9.1 GENERAL CONSIDERATIONS

9.1.4 Corrosion Model

Technical background of the proposal

Fig.1 Relation between state of corrosion of each longitudinal strength member and diminution tendency of mid-ship section modulus.

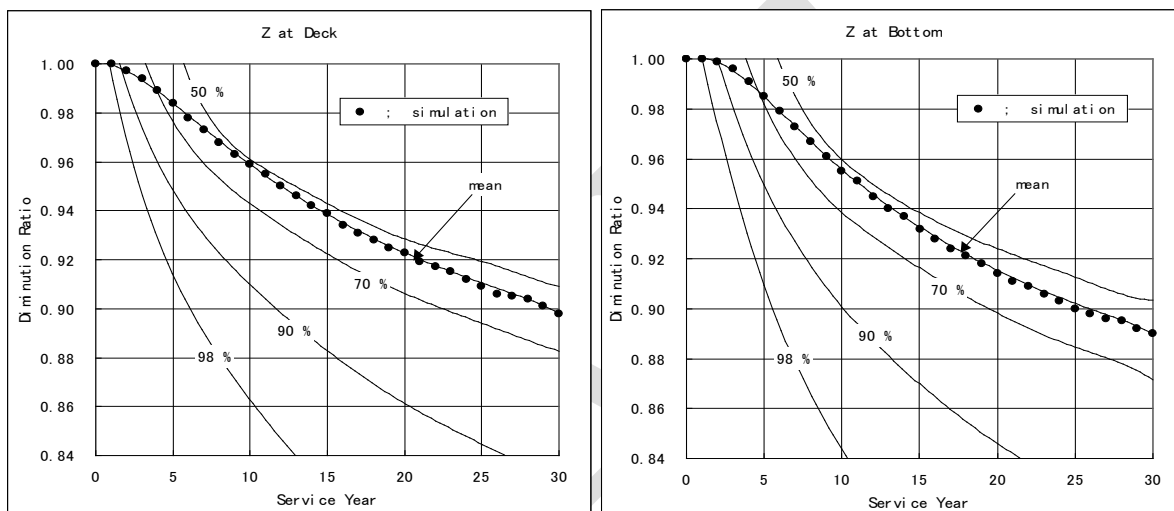
The diminution rate of the midship section modulus of a certain ship, whose principal dimensions are $L \times B \times D \times C_b = 310.0 \times 58.0 \times 29.5 \times 0.808$, was evaluated as shown in Fig. 1.

The diminution rates of the midship section modulus were evaluated when assuming that each member was uniformly diminished by the amount of corrosion that the cumulative probability of the diminution becomes 50%, 70%, 90%, and 98% respectively. And the evaluation was made when assuming that each member was uniformly diminished by the average value of the amount of corrosion. Moreover, the generation and the progress of the corrosion of each member were also simulated and the diminution rate of midship section modulus was evaluated. The average value of such an evaluation result of 500 cases is indicated as solid circle in Fig. 1. The difference of the evaluated section modulus by the simulation was about 1.3% in the coefficient of variance even if the maximum. It has been understood that the section modulus diminishes almost deterministically even if the amount of corrosion of each member varies stochastically very much. The result when assuming that each member was uniformly diminished by the average value of the amount of corrosion and the evaluation result by the simulation are almost corresponding.
